Subject: Virgil C. Summer Nuclear Station (VCSNS) Units 2 and 3  
Combined License Application (COLA) - Docket Numbers 52-027  
and 52-028 - SCE&G Voluntary Submittal Related to the  
Environmental Report Chapter 8

The enclosure to this letter provides an update to the ER information in response to DEIS comments (reference 2) related to the Santee Cooper need for power analysis.

## **VCSNS Units 2 & 3**

### **Environmental Report Chapter 8 Update for Santee Cooper**

Figure 8.2-1

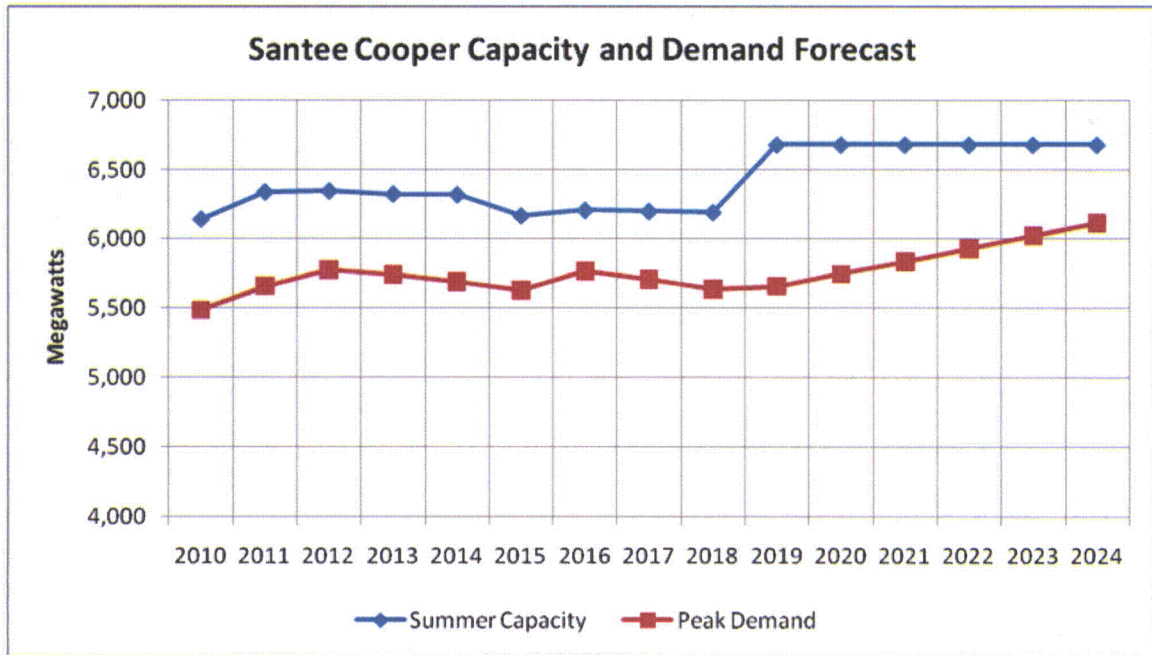
In light of the developments noted in Section 8.2, Santee Cooper is reviewing other aspects of its capital improvement program and long-term power supply plan. Currently, Santee Cooper is in active discussions with a number of utilities regarding long-term power sales arrangements, the total of which is over 2,000 MW. Of this, at least 300 MW are the subject of current contract negotiations and are reasonably expected to be finalized by the end of 2010. In addition, Santee Cooper is evaluating proposed environmental regulations to determine their potential impacts on the operation of existing generation resources. These regulations could result in the decision to mothball or retire up to approximately 450 MW of existing resources. Also, Santee Cooper previously included 250 MW of purchased renewable capacity and energy that was assumed to be under contract by 2020. So far, efforts to procure that capacity and energy have resulted in the negotiation for approximately 50 MW of the previously assumed 250 MW. Collectively, these efforts are reflected in an update to the forecast as shown in Table 8.2-1 “Forecast Update” and illustrated graphically in Figure 8.2-1.

Figure 8.2-2

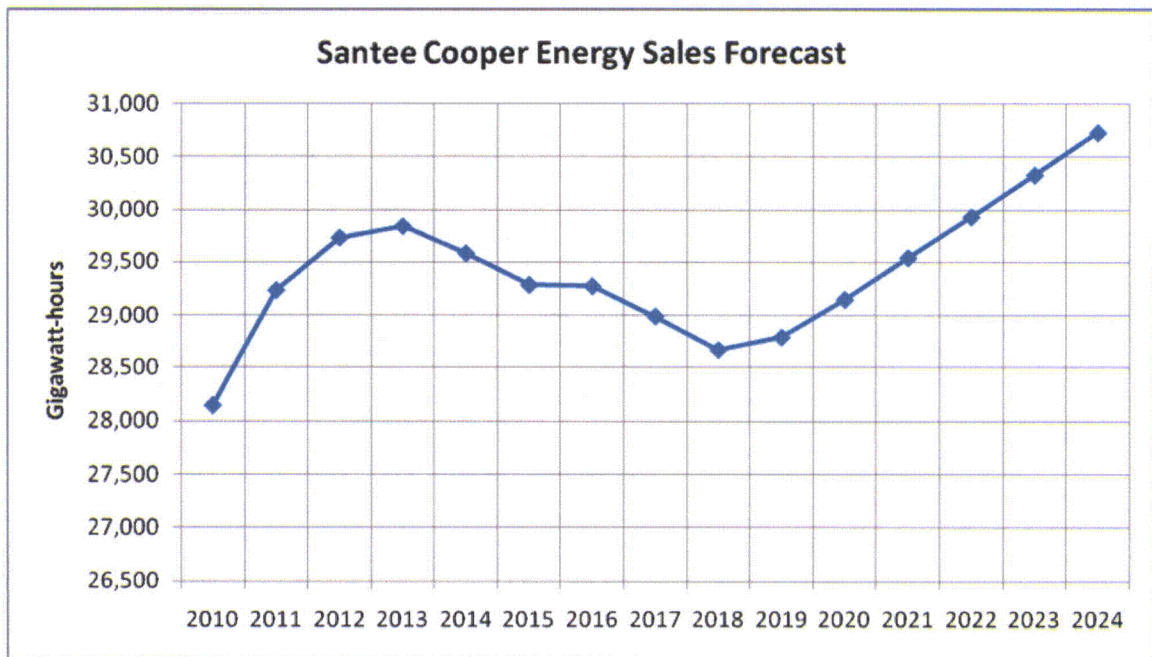
Additionally, Figure 8.2-2 illustrates the results of the most recent 2009 Santee Cooper energy sales forecast updated to reflect the impact of the recent developments noted above.

Based on the updated forecast, Santee Cooper projects its energy sales to grow approximately 1.2% per year for the next 15 years, rising from 25,813 gigawatt-hours in 2009 to 30,729 gigawatt-hours in 2024. In part, this growth is attributable to Santee Cooper directly serving one of the state's fastest growing areas, Myrtle Beach. By way of illustration, Santee Cooper's growth rate in its direct service area averaged 3.5% in the 5 years preceding 2008 and prior to the economic downturn (Santee Cooper 2007). It should be noted that the projected growth rate does not include growth in Santee Cooper's direct-served large industrial sector. Growth in the large industrial sector beyond contract amounts is not assumed in the load forecast projections. In addition, these growth rates do not reflect any sales above the 300 MW mentioned above that might result from current power sales discussions.
